**RE: Substantive DA Amendment Opal Ridge (Penhorn) Special Planning Area**

Clayton Developments Limited on behalf of Opal Ridge Developments Limited (ORDL) and Opal Ridge Suites GP Limited is pleased to submit a substantive amendment request to the Opal Ridge (Penhorn) development agreement.

The purpose of this request is to fully implement the recent Housing Accelerator Fund changes to Penhorn, and to amend the existing development agreement to measure building height in storeys, as now enacted in the Land Use By-law that the development agreement references.

Figure 2 Proposed Schedule E-1 Building Height Precincts with revised height in storeys for Blocks C, D, F and G.

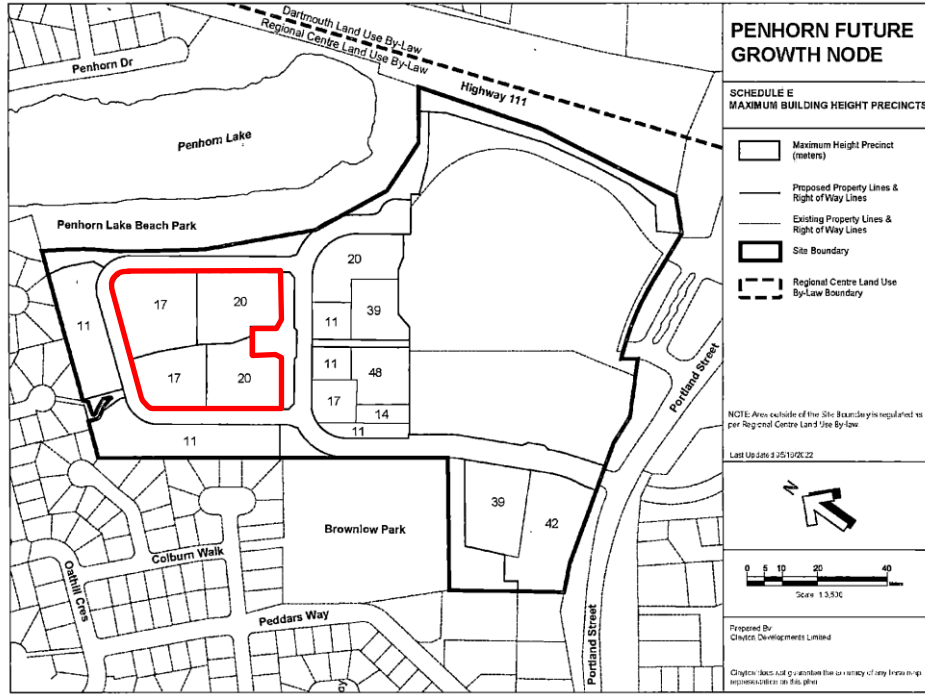
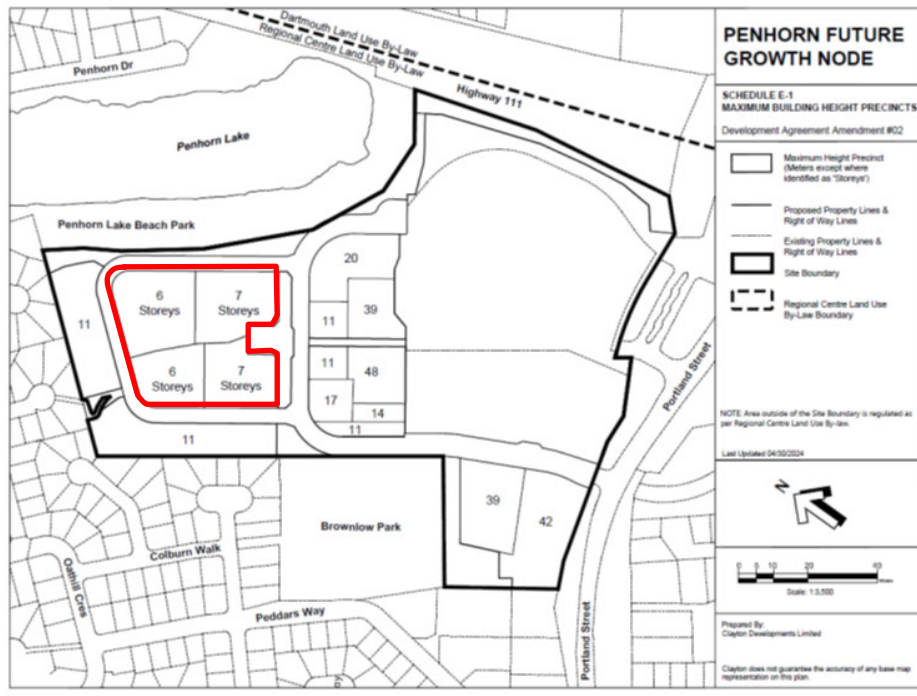
The current development agreement enables building heights of 17m and 20 metres for Blocks C, D, F and G via Schedule E (See below highlighted in Red).

Within these heights, a building with either 6 storeys at 17 m or 7 storeys at 20m is possible with nine foot floor-to-floor heights, or larger floor to floor heights with a sunken building grading. Unfortunately, the Concept Plan - Schedule B has some inconsistent language which identifies building height in storeys which does not necessarily achieve the full building heights enabled on Schedule E. While the Concept Plan is conceptual and subject to the terms of the agreement including Schedule E, this mismatch is confusing. We would like this amendment to clarify this.

We are seeking to achieve the benefits of these changes through amendment to the development agreement which references the HR-2 Zone. Although we are seeking the benefits of the HAF amendments, our intent is to keep the transitions in building height identified in Schedule E specifically over Blocks D and F which are proposed to be limited to 6 storeys, which is similar to the existing 17 m height limit but is slightly more flexible being measured in storeys.

1. Achieve revised building height measurements enabled for mid-rise buildings through the HAF amendments with context sensitive amendments relating to the original intent of the Penhorn FGN development agreement. These changes would revise Block C and Block G to 7 storeys and Blocks D and F to 6 storeys via an amendment to Schedule E Maximum Building Height Precincts.
2. Revisions to the Schedule B - Concept Plan to identify heights which are consistent with Schedule E. Alternatively the removal of building heights from Schedule B would also be appropriate.

Proposed Amendment		
Block	Storeys Identified on Concept Plan (Schedule B-1)	Storeys Identified proposed Maximum Height (Schedule E-1)
C	7	7
D	6	6
F	6	6
G	7	7

Figure 2 – Proposed building at 7 stores (approx.. 21.94m)

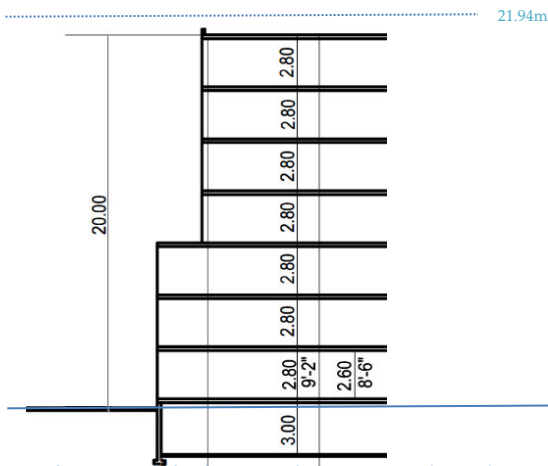
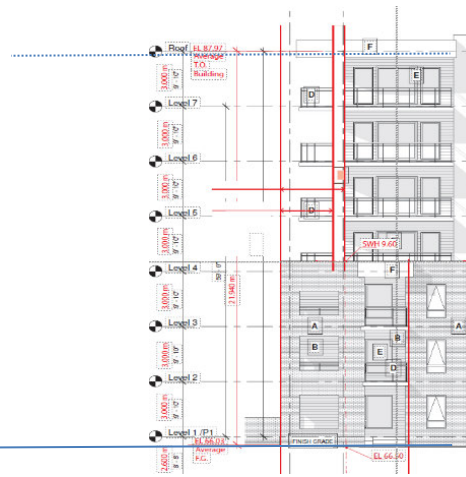
While designing the building, it was determined that additional floor to floor height was needed to accommodate a specific type of heating and cooling infrastructure. This infrastructure is recommended for its energy efficiency but require additional floor to floor height so they can be fully enclosed in unit ceilings without the need for expensive and visibly unappealing bulkheads. Further information outlining the benefits of the proposed heat pumps can be found in Attachment C.

It was determined that approximately 8 inches (0.2m) was floor to floor height was needed per floor. In total, an additional 1.94 m (6.36 feet) in building height is required.

Achieving the HAF benefits would resolve our issue under the existing development agreement which has a finite measured heights. The flexibility to measure height using floors rather than metres resolves our issue and enables the installation of energy efficient heating and cooling infrastructure.

**Project / Design Rationale - reduction of side yard setbacks adjacent PCF Zone.**

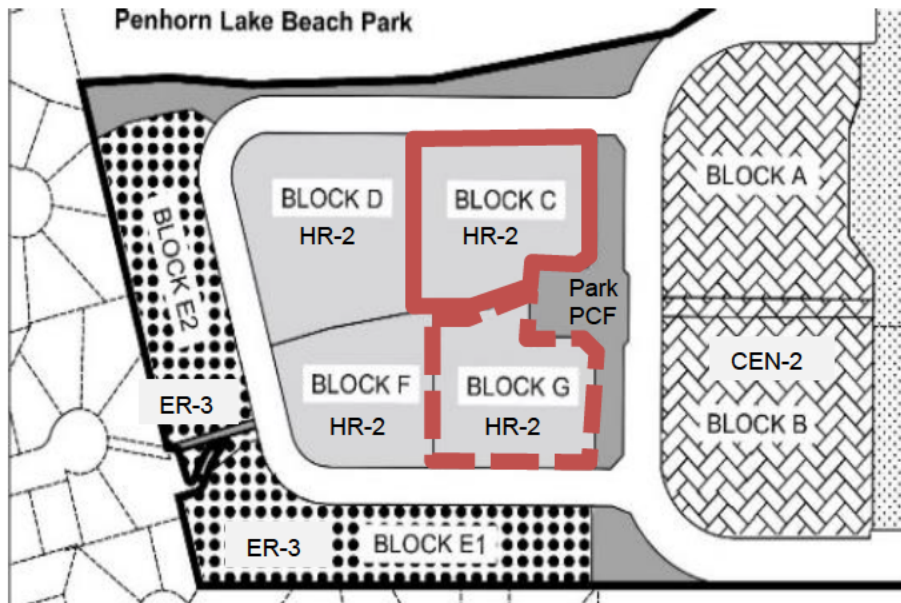
The area impacted in the concept plan is shown in a solid red line below (Block C) but confined to the area adjacent the park. Please note that via a variance process we have received a reduction in the setback from PCF Zone from 6 m to 3 m for the adjacent Block G. For greater certainty we have applied to amend the development agreement rather than going through a future variance for the subject lands (Block C):

The request deals with a reduction in side-yard setbacks adjacent the linear parkway but not the adjacent hardscape plaza. The diagram below identifies the specific area where the setback would normally be required (orange line 6m setback) and the proposed setback (yellow line 3m). As noted, a variance has previously been granted for Block G enabling the proposed reduction.

LUB Regulation	Requirement	Requested Change
Minimum Side Yard Setback Section 198(1)(a)(ii)	6.0 metres from the side lot line abutting a PCF zone for any mid-rise, tall mid-rise, or high-rise building.	3 metres (reduction of 3 metres)

**PENHORN FUTURE GROWTH NODE**  
**SCHEDULE B-1**  
**CONCEPT PLAN**  
 Dartmouth, Nova Scotia  
 June 3 2024  
 NTS

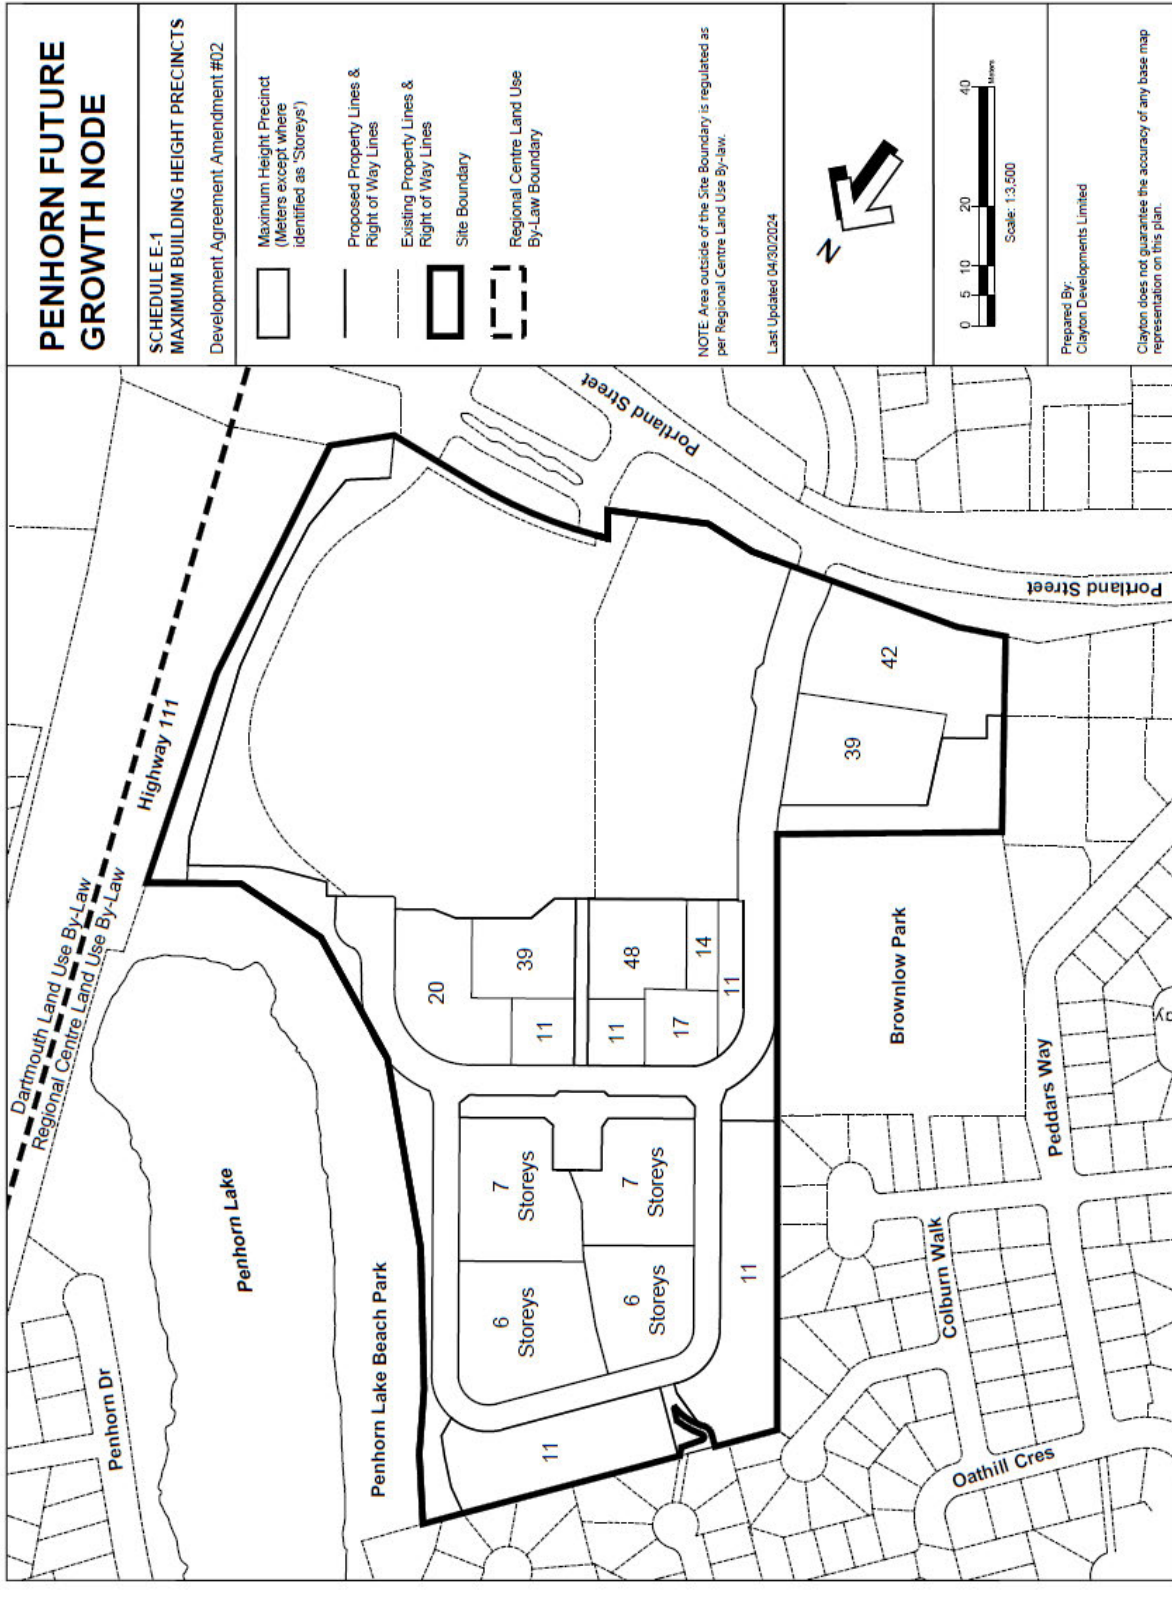
1. Schedule E (Maximum Building Height Precincts) be replaced by Schedule E-1 (Attachment A) with heights measured in storeys for Blocks C, D, F and G. The proposed heights enable the equivalent number of storeys (6 or 7) enabled under the heights in the existing Schedule E (17 or 20 metres).
2. Schedule B (Concept Plan) be replaced by Schedule B-1 with building heights that coordinate with Schedule E-1 or the removal of all building heights from the concept plan.
3. A reduction in the side-yard setback from a PCF Zone to 3.0 metres to address a ground floor unit type proposed adjacent the parkway and an improved building/parkway interface. This will require the insertion of a new clause enabling the reduced setback.
